10. COA-044098-2018

Commission of
Architectural Review

STAFF REPORT

Construct a serpentine brick privacy wall in the rear yard.

Figure 2. Rear of 2100 East Clay Street, 1993

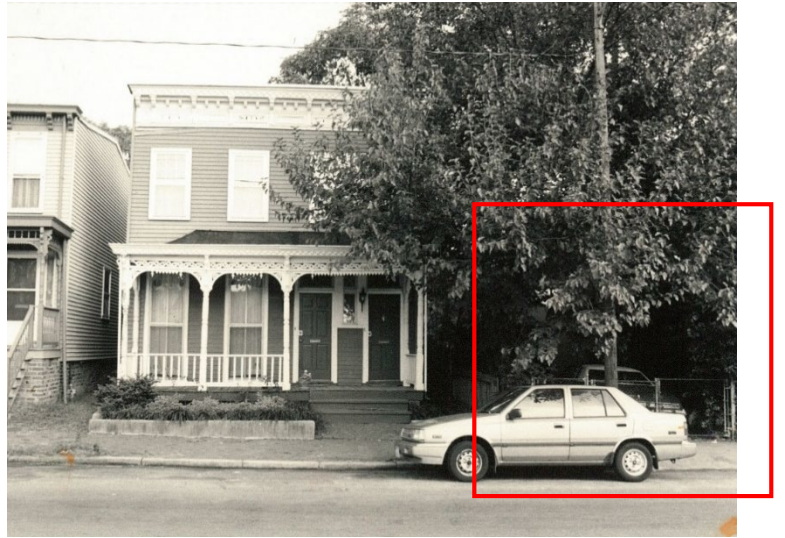
There are two existing brick piers at the rear of the property, flanking an existing curb cut. Staff was unable to find any documentary evidence of a prior brick wall. However, a photograph from 1993 may show a chain link fence between the piers (see Figure 2).

Staff finds that the proposed serpentine design is not consistent with existing fences and walls found in the district. There are few street-front fences or walls in the surrounding area. There are limited examples of wooden picket fences in front yards and wooden privacy fences in rear yards. Staff recommends a straight brick wall be installed in the proposed location.
